RTCA Special Committee 209, Working Group #1

Mode S Transponder MOPS Maintenance

**Detailing The Proposed Changes to Figures in
Order to Harmonize DO-181D and ED-73C**

**(This version was created after WG-1 Meeting #3 to add some Figures and clarifications before
sending to WG-49 for their November meeting)**

Figure 2-19R1: All Data Link Transponders B Protocol

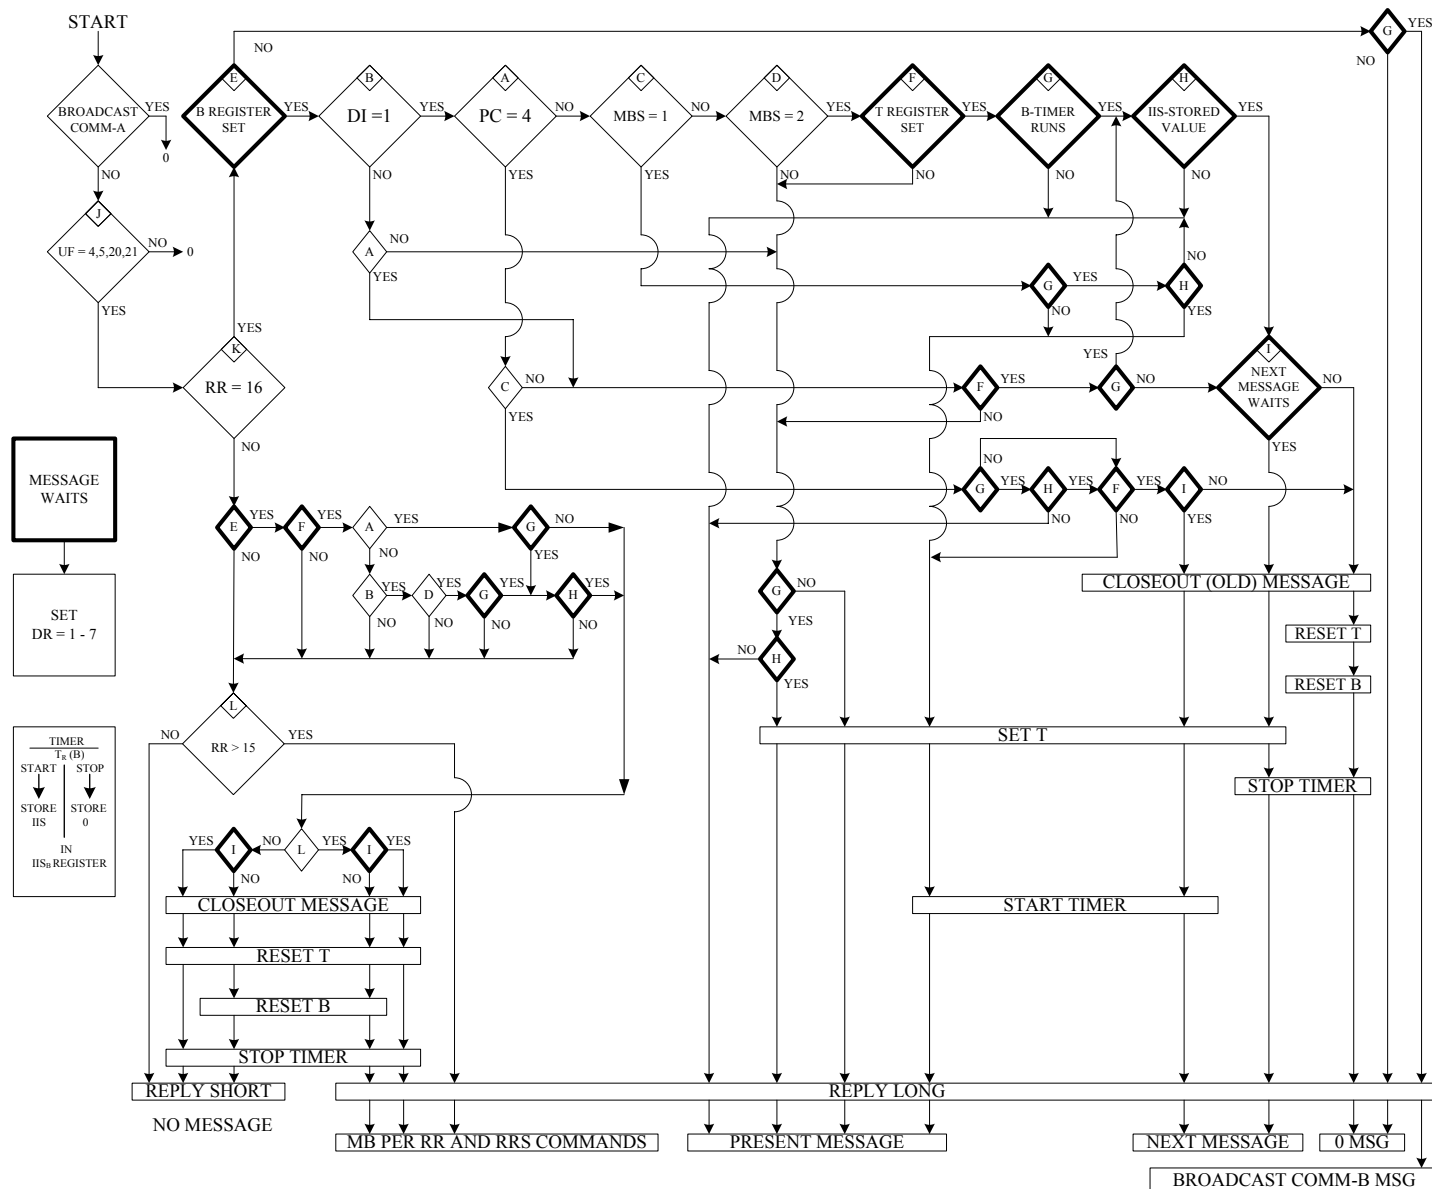
10. Figure 2-19 in DO-181D and Figure 3-18 in ED-73C has been the topic of many separate discussions in previous meetings. Proposed changes were originally identified in Working Paper ModeS-WP01-06, with a corresponding change to the test procedure identified in Working Paper ModeS-WP01-05. The latest revision of the suggested changes are explained in detail in Working Paper ModeS-WP03-11. The version of Figure 2-19R1 shown below has been updated as per the changes in ModeS-WP03-11.

Figure 2-21: Comm-C Message Handling

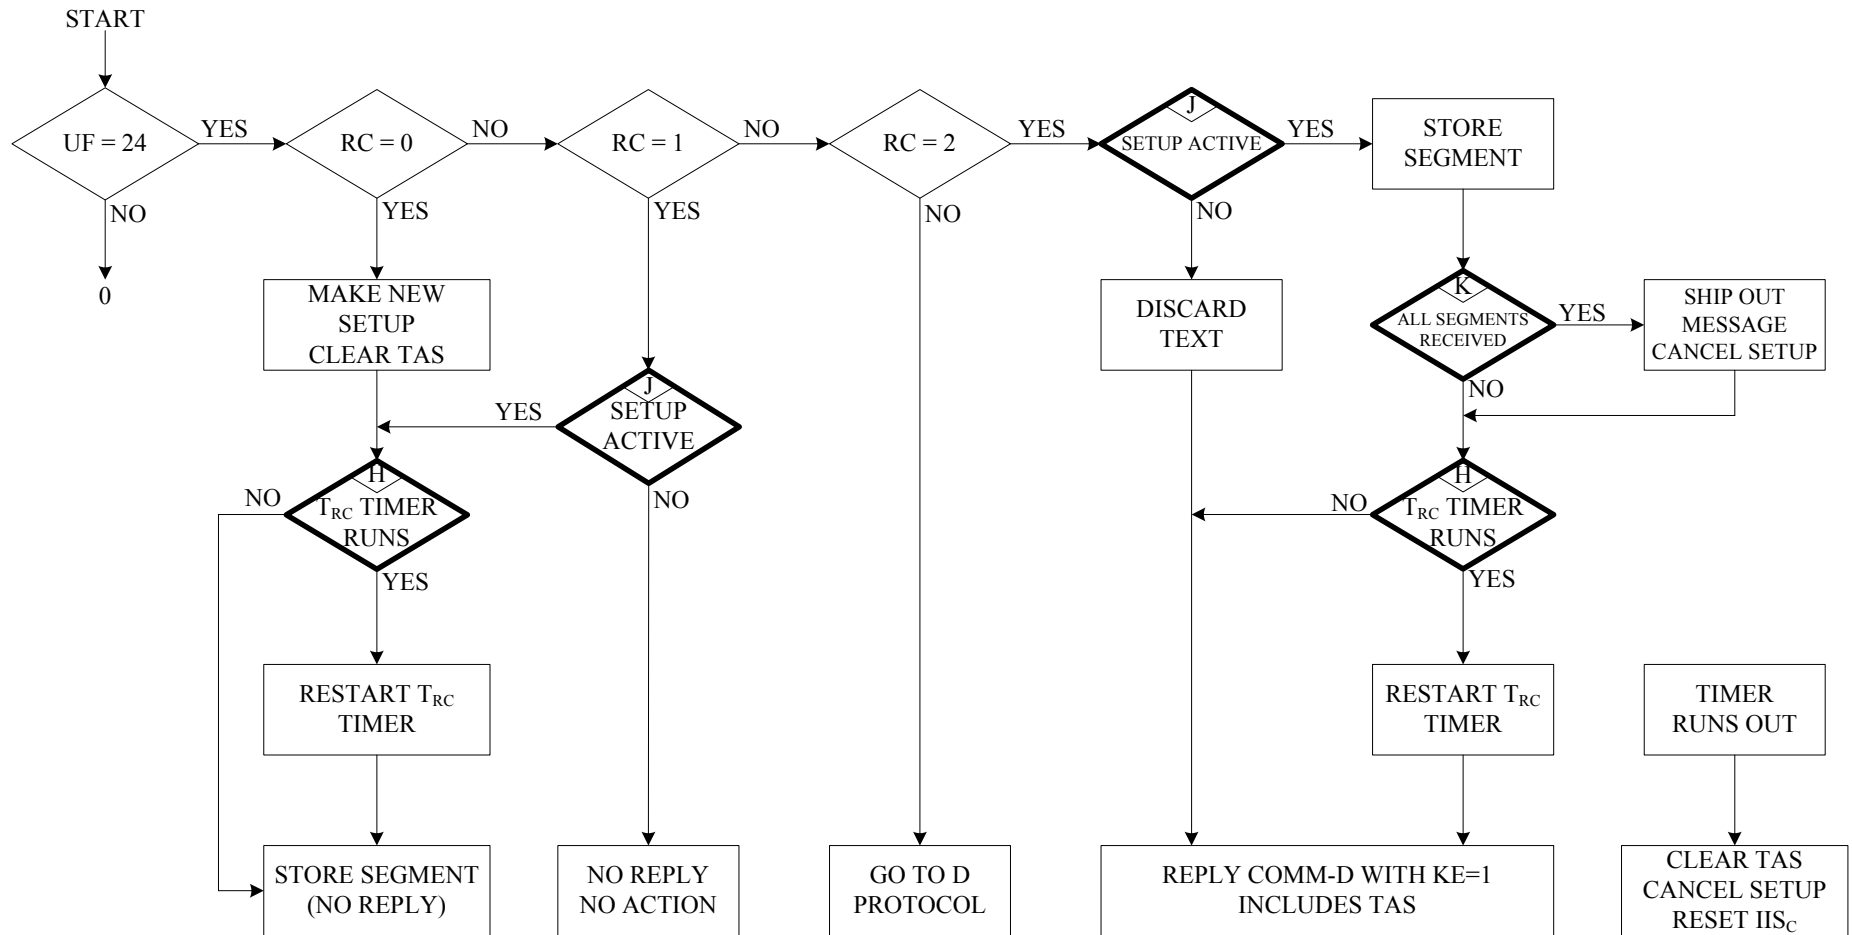
13. Figure 2-21 in DO-181D appears to have been updated at least once since Figure 3-20 in ED-73C was last updated, and we believe that Figure 2-21 is accurate, and represents the correct flow chart for Comm-C Message Handling. We recommend that Figure 3-20 in ED-73C be replaced with the current Figure 2-21 from the latest draft of DO-181D, as shown below.

Figure 2-xx: Enhanced Comm-C Message Handling

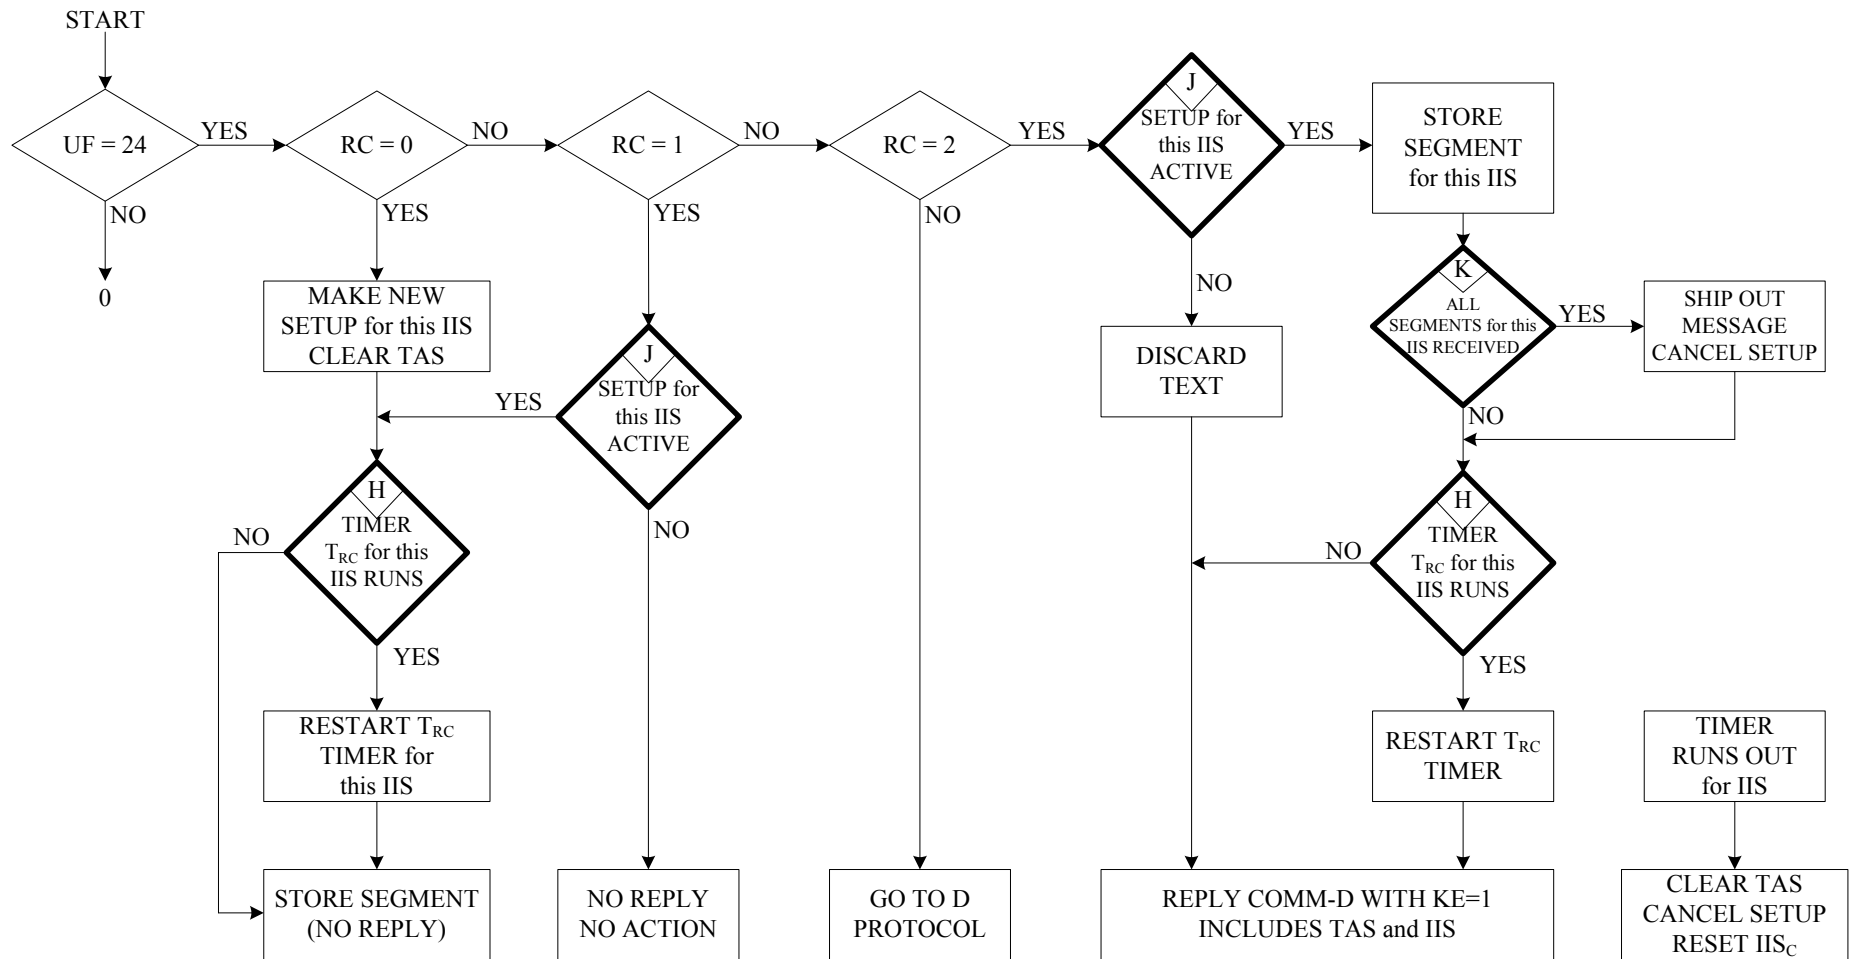
14. ED-73C, Figure 3-20A for “Enhanced Comm-C Message Handling” should be based on the version of DO-181D, Figure 2-21 above. We propose that the Figure for “Enhanced Comm-C Message Handling” be accepted in both documents as the following:

Figure 2-23R1: WITH CHANGES PROPOSED TO HARMONIZE WITH ED-73C Figure 3-22

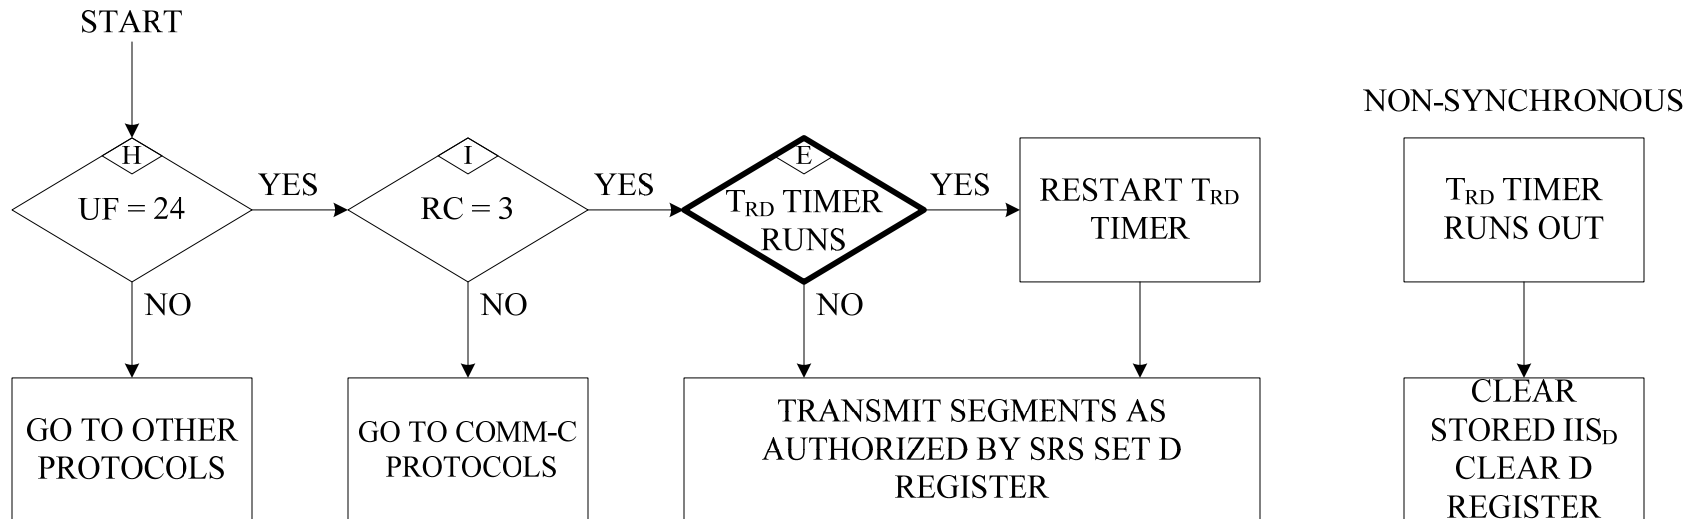
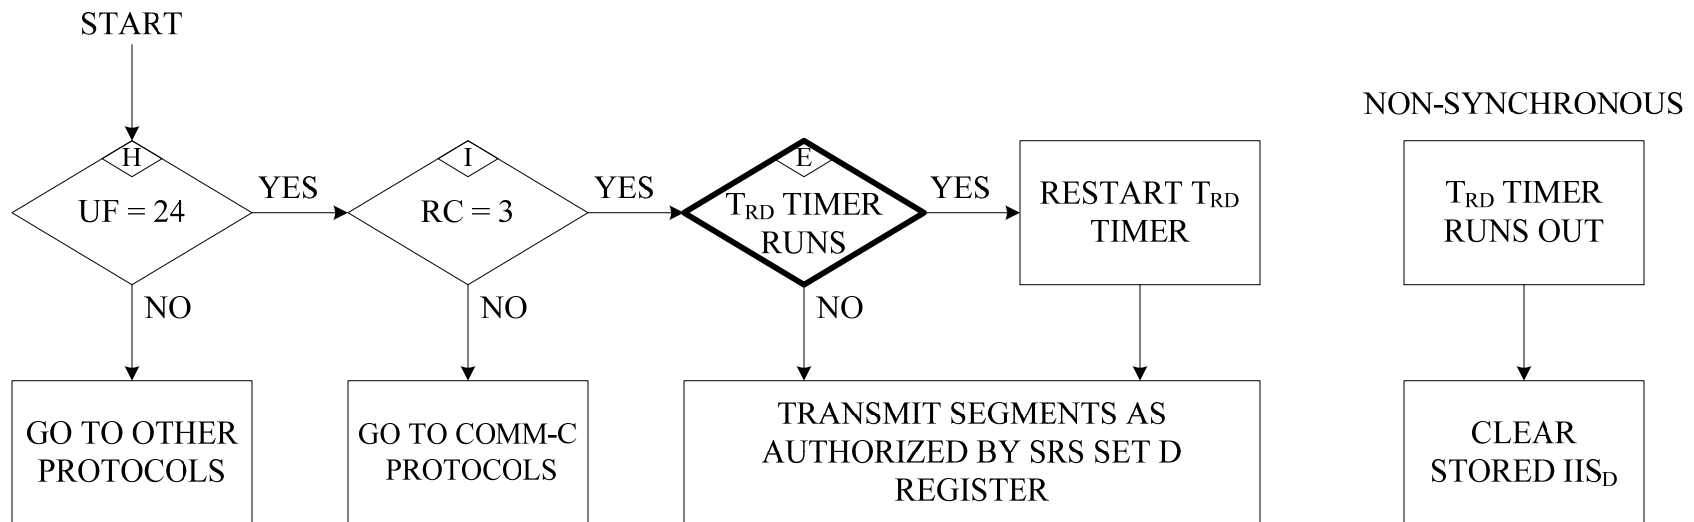
15. A Visio version of ED-73B, Figure 3-21A – “Enhanced Comm-D Reservation and Close Out” has been generated and it is suggested that it be inserted as-is into DO-181D in the appropriate location.
16. Figure 3-22 in ED-73C has an error in the outputs of decision box “E” where the “YES” and “NO” are reversed. This is correct in Figure 2-23 in DO-181D. However, there is different error in Figure 2-23 in that whenever the T_{RD} Timer runs out, the “D” Register should NOT be cleared as shown in the bottom box under the “Non-Synchronous” boxes on the extreme right of the figure below. The original DO-181C, Figure 2-23, and the proposed revised Figure 2-23R1 for DO-181D appear below.

Figure 2-xx: Enhanced Comm-D Message Handling

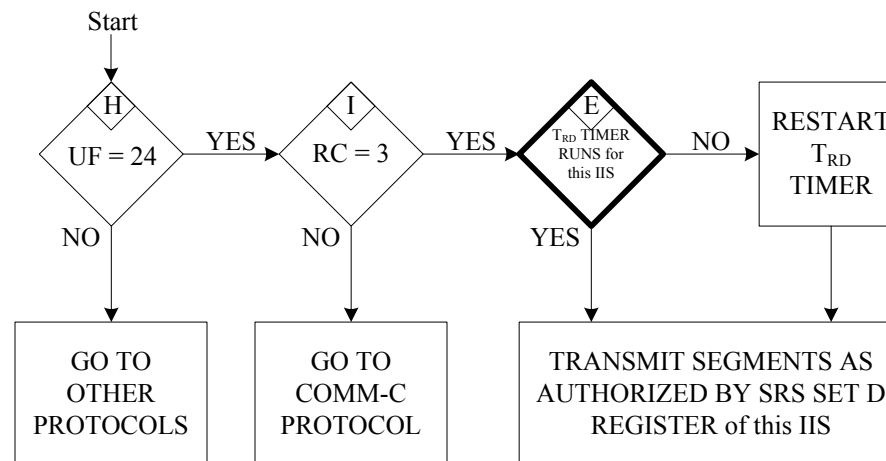
17. Figure 3-22A in ED-73C contains the same error in the outputs of decision box “E” where the “YES” and “NO” are reversed. With this error corrected, we proposed that the figure below be accepted and placed into both documents in the appropriate places.
